# MVEA YODER SUBSTATION

## EL PASO COUNTY

### SITE PLAN

### AUGUST 2018

MVEA YODER SUBSTATION
SITE PLAN

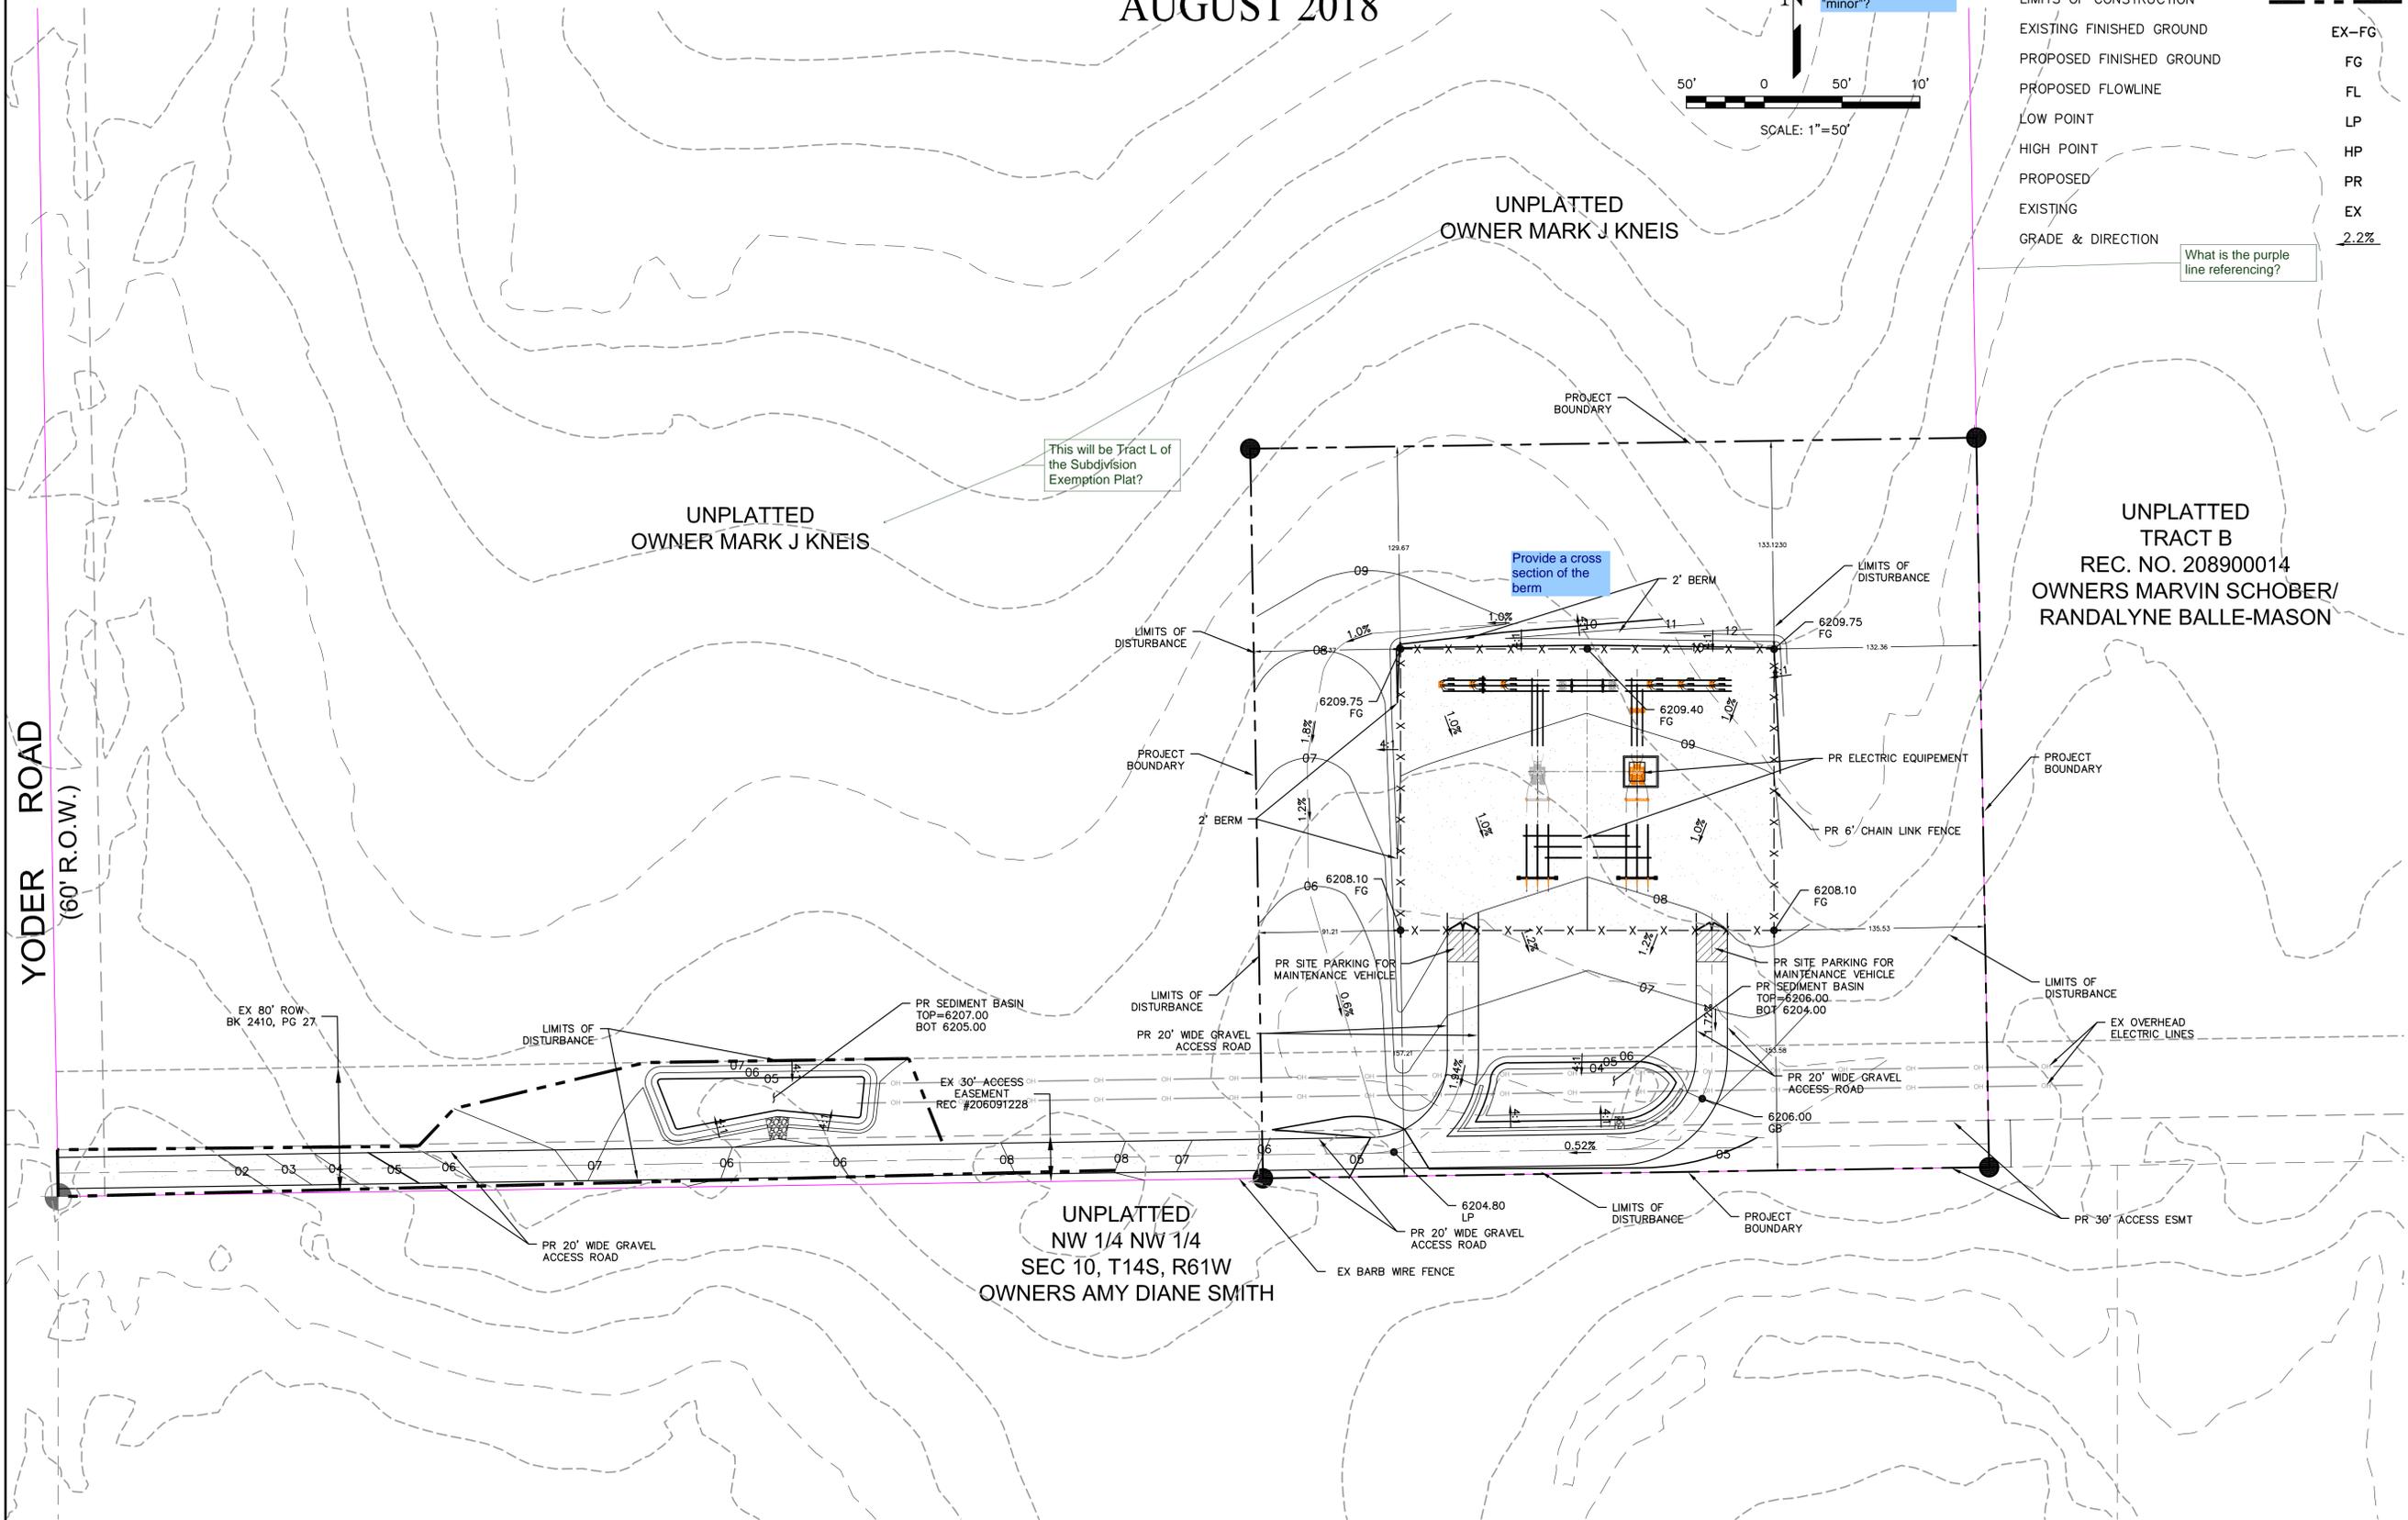
Clarify the difference. Should this be "minor"?

What is the purple line referencing?

This will be Tract L of the Subdivision Exemption Plat?

Provide a cross section of the berm
